LINE	QUANTITY	UOP	CAT. NO.	ITEM NUMBER	UNIT PRICE	AMOUNT
***** ADDENDUN NO. 1 *****						
THIS ADDENDUM IS ISSUED TO PROVIDE THE ATTACHED MANDATORY PRE-BID ATTENDANCE ROSTER, SUBSTITUTION REQUEST, MANDATORY PRE-BID QUESTIONS AND ANSWERS, REQUESTS FOR SUBSTITUTION, BID CLARIFICATIONS AND DRAWING SK1.						
BID OPENING HAS CHANGED TO: 06/10/09 AT 1:30 PM						
0001	1	LS		968-20		
NEW BATHHOUSE AND POOL LAUREL LAKE						
***** THIS IS THE END OF RFQ DNR209181 ***** TOTAL:

Laurel Lake New Bathhouse and Pool Renovation
Requisition DNR209181
Pre-Bid Meeting Questions and Answers

**Laurel Lake New Bathhouse and Pool Renovation
Requisition DNR209181**

West Virginia Division of
 Natural Resources
 Parks and Recreation
 Laurel Lake WMA
 New Bath House and Pool Renovations

REVISED FIBERGLASS MAIN DRAIN BOX

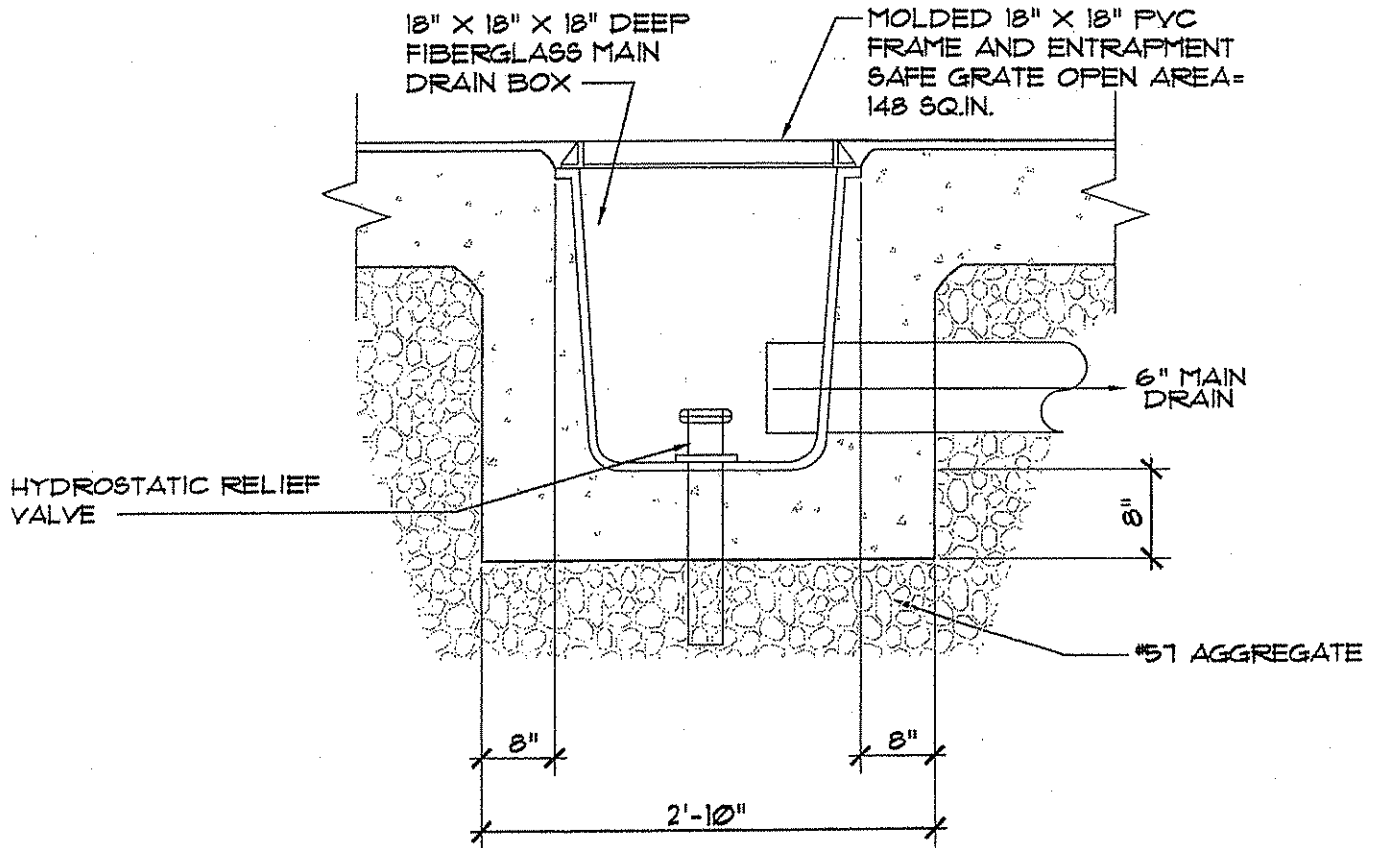
Answer: After a review of the plans and the site conditions, hydrostatic relief valves will be added to the main drains. The lean concrete indicated as fill in the deep end of the pool will be replaced with aggregate. These items will be addressed more specifically by addendum.

3. Drawing C4 – Change Ladder Designation No. 7 from a two-tread ladder to a three-tread ladder.
4. Drawing C5 – Delete the detail 1/C5, Fiberglass Main Drain Box, and substitute attached Sketch 1, Revised Fiberglass Main Drain Box to include a hydrostatic relief valve.
